Access Compliance Report

Public Rights-of-Way

Intersection ID: 12066	Main Street: WEYLAND_AV	Cross Street: MARLOWE_AV	Location: SE
ADA ID: 6D5817463CB9	Ramp Type: PerpDiag	Initial Pass/Fail: Fail	Overall Compliance: No
		Severity Score: 47.5

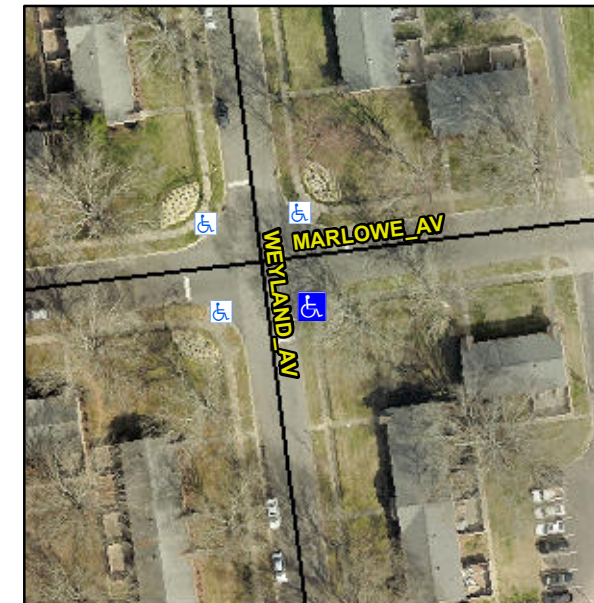
Not Found, R304.5.1, R304.2.2

Compliance	Description	Data	Compliance	Description	Data
N/A	Ramp Length (in)	78.5	No	Ramp Slope (%)	10.3
No	Ramp Width (in)	30.5	Yes	Ramp XSlope (%)	0.2
N/A	Flare Type LT	N/A	N/A	Flare Type RT	N/A
N/A	Flare Slope LT (%)	N/A	N/A	Flare Slope RT (%)	N/A
N/A	Flare Traversable LT?	N/A	N/A	Flare Traversable RT?	N/A
N/A	Landing Length (in)	N/A	N/A	DWS Provided?	N/A
N/A	Landing Width (in)	N/A	N/A	DWS Contrast?	N/A
N/A	Landing Slope (%)	N/A	N/A	DWS Length (in)	N/A
N/A	Landing X Slope (%)	N/A	N/A	DWS Full Width?	N/A
N/A	Landing Curb? (Y/N)	N/A	N/A	DWS Offset (in)	N/A
N/A	Shared Landing?	N/A			
N/A	Gutter Ponding?	N/A	N/A	Gutter Slope (%)	N/A
N/A	Gutter Lip Ht (in)	N/A	N/A	Gutter X Slope (%)	N/A
N/A	Painted X Walk1?	No	N/A	Painted X Walk2?	No
	X Walk 1 Direction	To N		X Walk 2 Direction	To W
N/A	X Walk 1 Width (in)	N/A	N/A	X Walk 2 Width (in)	N/A
	X Walk 1 Slope (%)	2.8		X Walk 2 Slope (%)	4.3
	X Walk 1 X Slope (%)	2.5		X Walk 2 X Slope (%)	2.0

Possible Solutions:

Remove & Replace Curb Ramp With Two New Directional Ramps or Equivalent.
